International Aero Engines SERVICE BULLETIN

Subject: Transmittal of Revision 2 to Service Bulletin
No.V2500-ENG-72-0105

**ENGINE - LP COMPRESSOR - INTRODUCE A SEGMENTED
REAR FAIRING ASSEMBLY**

V2500-ENG-72-0105

Rear Fairing Assembly - After Alteration
Figure 2

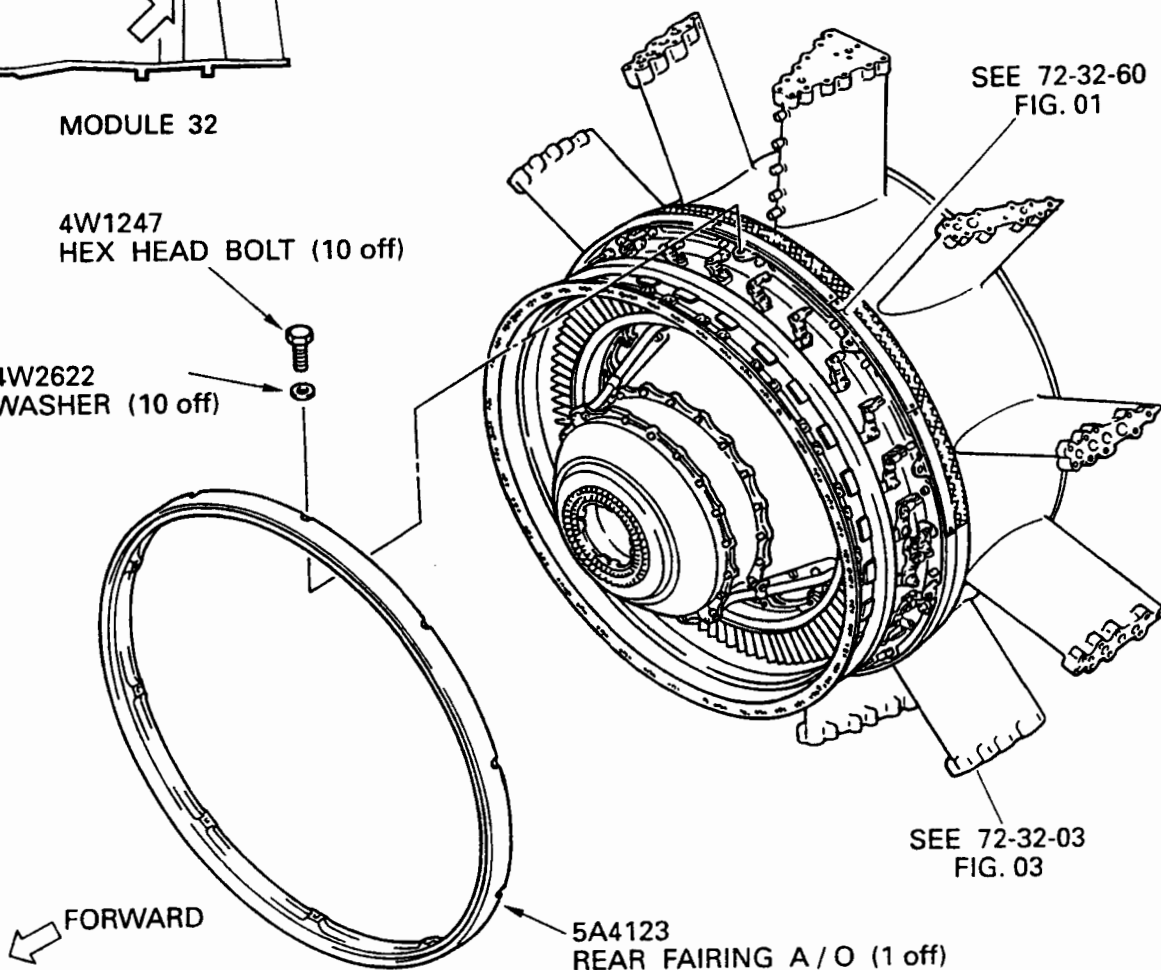
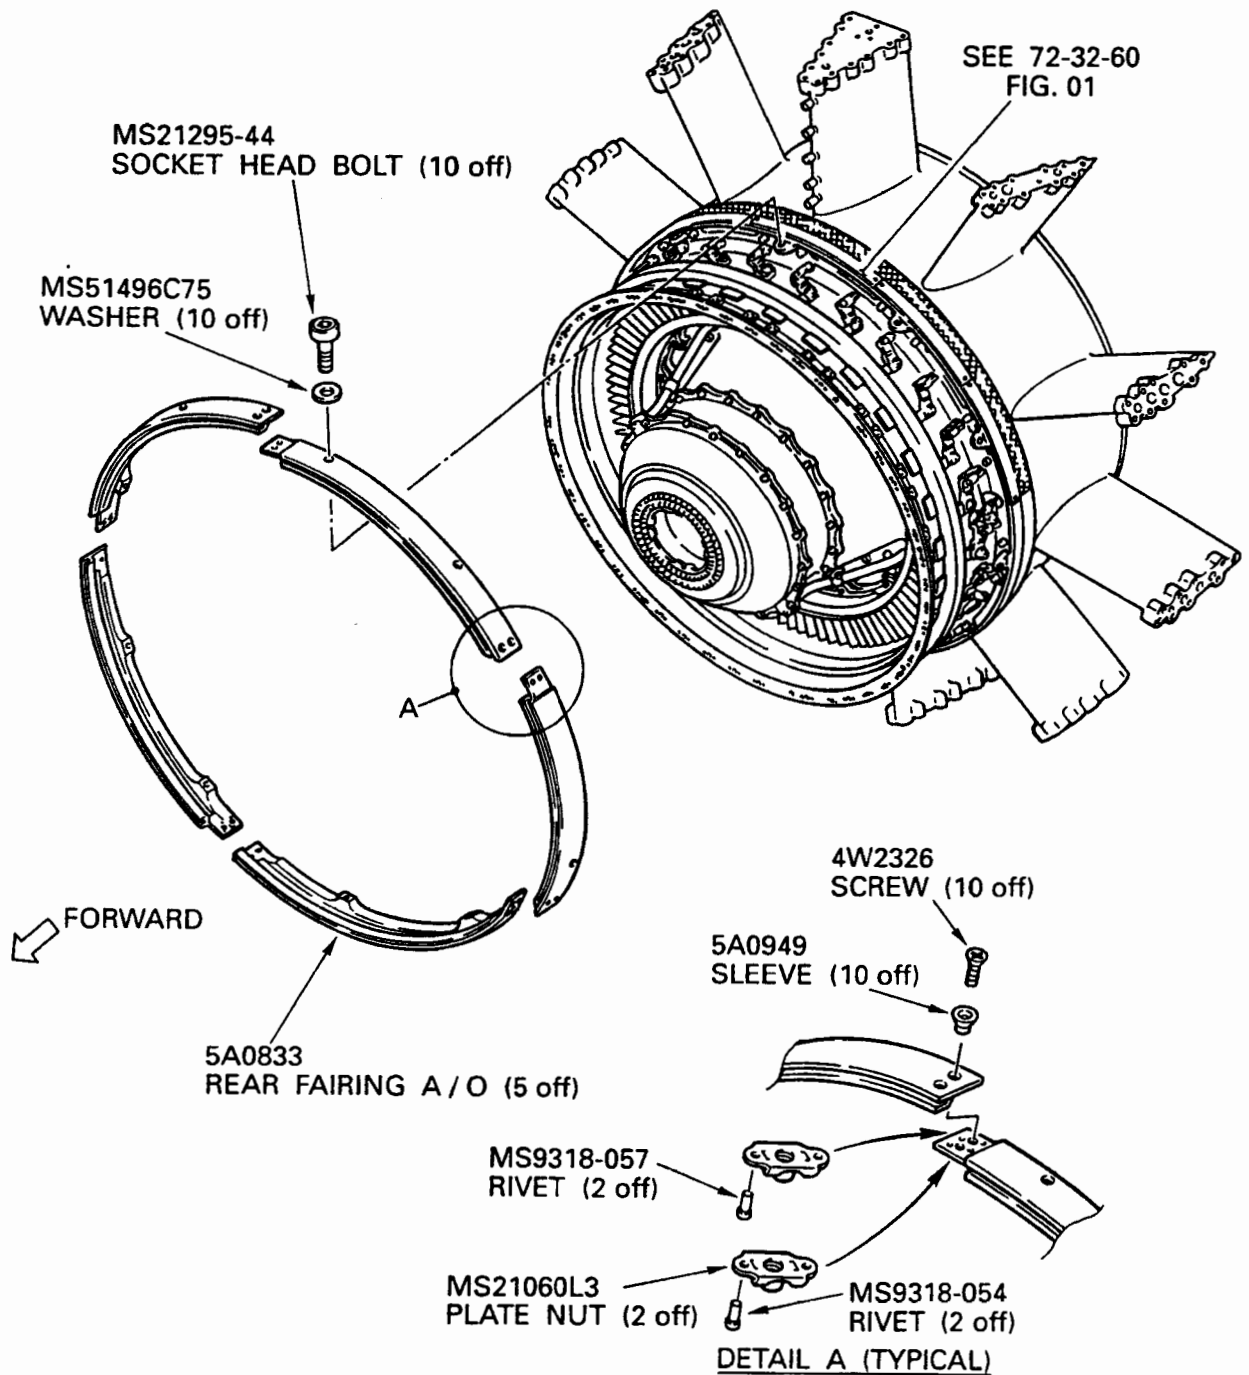
- (1) The changes introduced by this Bulletin are as follows:
 - (a) New segmented Fairing Assembly has been introduced to allow the removal and installation (See Figure 2).
- (2) This Service Bulletin must be incorporated prior to or concurrently with IAE Service Bulletin No. V2500-ENG-72-0103.

Assembly of the Rear Fairing Assembly
Figure 3

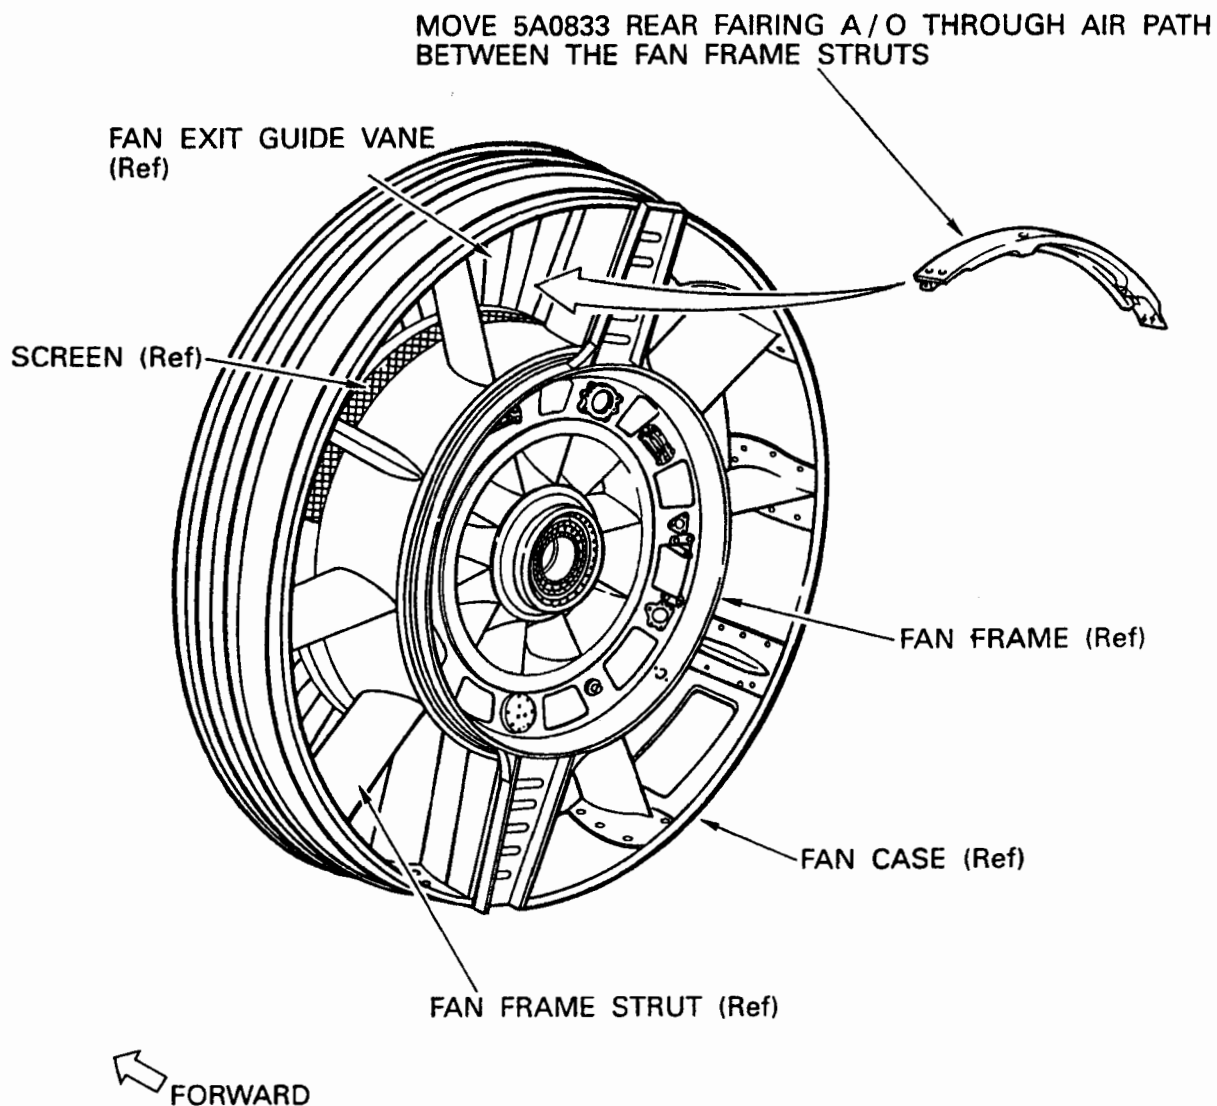
- (2) Assemble the five 5A0833, Rear Fairing Assembly, to the LP Compressor/Intermediate Case Module as follows (Refer to Figures 2 and 3):
 - (a) Move each 5A0833, Rear Fairing Assembly from the rear to the front through air path between the struts of Fan Frame Assembly.

- (b) Put the five 5A0833, Rear Fairing Assemblies in to specified positions.
 - (c) Adjust position of the five 5A0833, Rear Fairing Assemblies so that you can install the ten 4W2326, Screws, and the ten 5A0949, Sleeves correctly.

- (d) Install the ten 4W2326, Screws, 5A0949, Sleeves, MS21295-44, Socket Head Bolts, and MS51496C75, Washers to the five 5A0833, Rear Fairing Assemblies. Tighten the Screws and the Bolts lightly.

- (f) Torque each 4W2326, Screw to 36 - 45 lbf·in (4,00 - 5,00 Nm).
 - (g) Torque each MS21295-44, Socket Head Bolt to 85 - 105 lbf·in (10,00 - 12,00 Nm).
